Project #21-062
Blue Springs Business Park Bldg. #3
Located at approximately 1200 N. 800 W.

Project Name: Blue Springs Business Park Building #3
Proponent / Owner: Gus Pacheco / Blue Springs Business Park LLC
Project Address: Approx. 1200 North 800 West
Request: Design Review Permit
Current Zoning: Industrial Park (IP)
Type of Action: Quasi-Judicial
Hearing Date: October 14, 2021
Submitted By: Russ Holley, Senior Planner

Staff recommends that the Planning Commission **conditionally approve** a Design Review Permit for Project #21-062, Blue Springs Business Park Building #3, in the Industrial Park (IP) zone located at approximately 1200 North 800 West, TIN #05-050-0008.

Figure 1 shows the proposed building #3 front façade facing 800 West

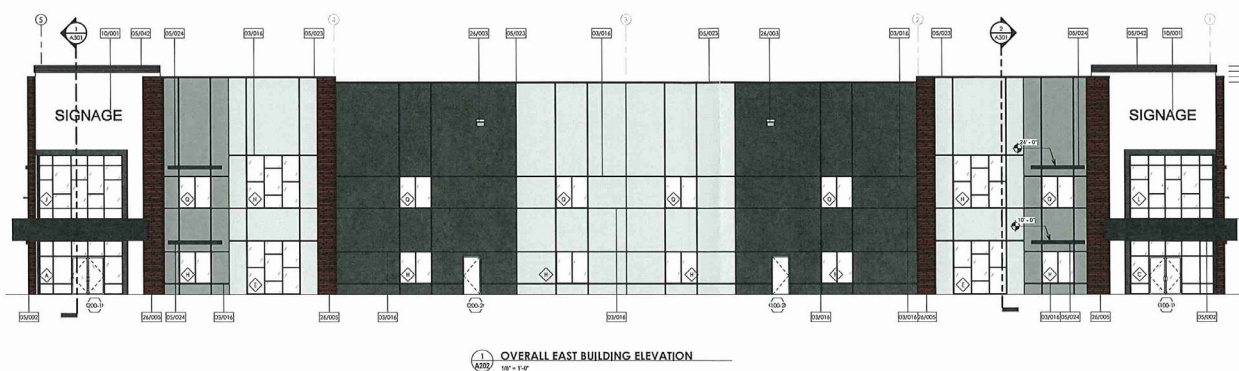
are tilt-up textured concrete in a variety of earth-toned colors with small vertical accent composite (wood-like) sections. The 1200 North street facing façade is shown with 28% transparency and the 800 West facing façade is shown with 21% transparency, both shy of the 30% LDC standard. The other non-street facing facades show wall-breaks and other features at the minimum 40 linear foot increments. As conditioned with additional transparency and weather protection above primary pedestrian entrances, the building design meets the requirements in the LDC.

3. The Planning Commission utilizes their LDC 17.43.080 approval criteria to adjust the transparency requirement (less than 10% deviation) and approves 28% transparency for both the east and north street facing facades. This is consistent with previous Blue Springs Business Park building approvals.

Figure 2 shows the proposed site plan

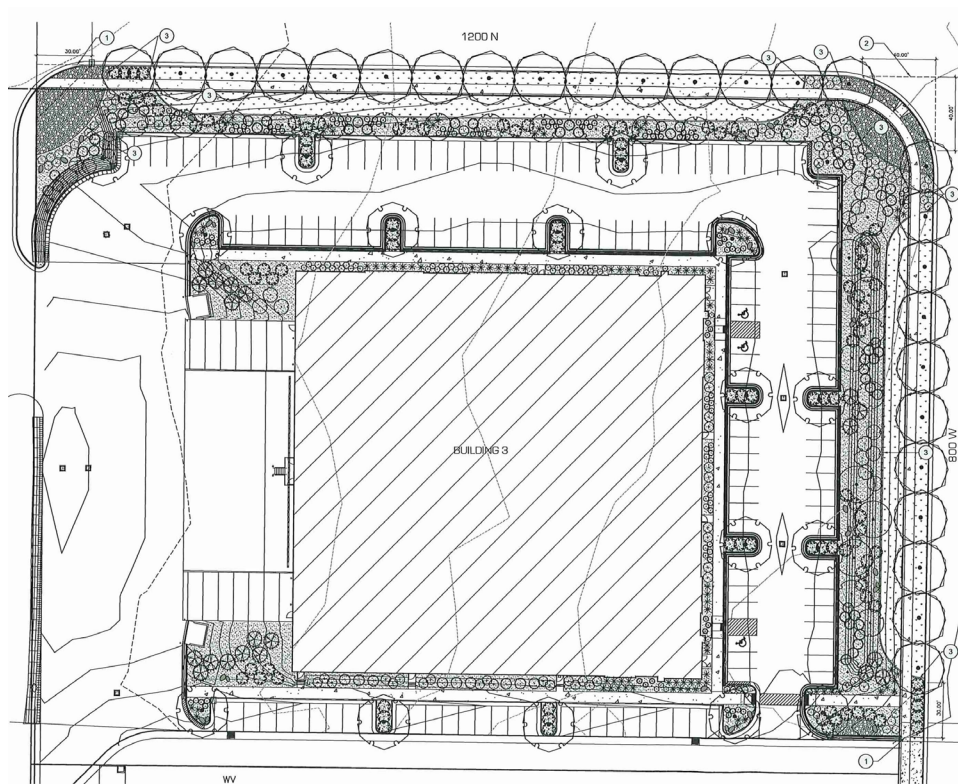
Front (east):	105'
Corner (north):	95'
Side (south):	35'
Rear (west):	140'
Parking(front/corner):	22-32'
Parking (side)	NA (shared parking lot)

As proposed, the project meets minimum setback requirements for the zone.

The parking location in the IP zone, and many other zones in the city, indicates placement at the side or rear. In cases where functionality and primary building use present conflicts, the Planning Commission may make exceptions to design issues as per LDC 17.43.080. The Planning Commission needs to make findings that don't compromise neighborhood character and future approvals. The neighborhood character in this part of town shows numerous parking lots positioned between the street and the building, and this particular proposal includes semi-truck loading docks and large truck circulation along the entire rear of the building, creating conflicts between automobile parking and semi-truck loading/unloading movements. Given the layout of the building's floorplans and context of the surrounding large-scale industrial businesses, separating the parking lot and semi-truck loading dock should be a consideration in this situation. Future projects with similar scales and configurations would be treated with the same continuity. As conditioned with the Planning Commission determining the location of parking lots, the project meets the standards in the LDC.

The LDC 17.31.090 requires commercial and industrial sites to include safe and convenient pedestrian circulation from the adjacent streets to buildings, parking areas and other outdoor gathering areas. When parking areas are proposed in areas adjacent to streets, LDC 17.32.070 requires additional landscaping/buffering to help screen asphalt parking areas. Type "B" screening, additional shrubbery and trees, is required when a parking lot is within 12'-25' of the street. This proposed shows parking area adjacent to both 800 West and 1200 North. Pedestrian circulation is shown to 800 West but not to 1200 North. As conditioned with full pedestrian circulation to both streets and Type "B" screening, the project complies with the LDC.

1. All standard conditions of approval will be recorded with the Design Review and are available in the Community Development Department.
2. The Planning Commission approves parking locations as shown.

4. A sidewalk connection shall be added linking the building entrance (northeast) to 1200 North street to the north.
5. A performance landscaping plan, prepared in accordance with §17.32 of the LDC, shall be submitted for approval to the Community Development Department prior to the issuance of the building permit. The plan shall include the following:
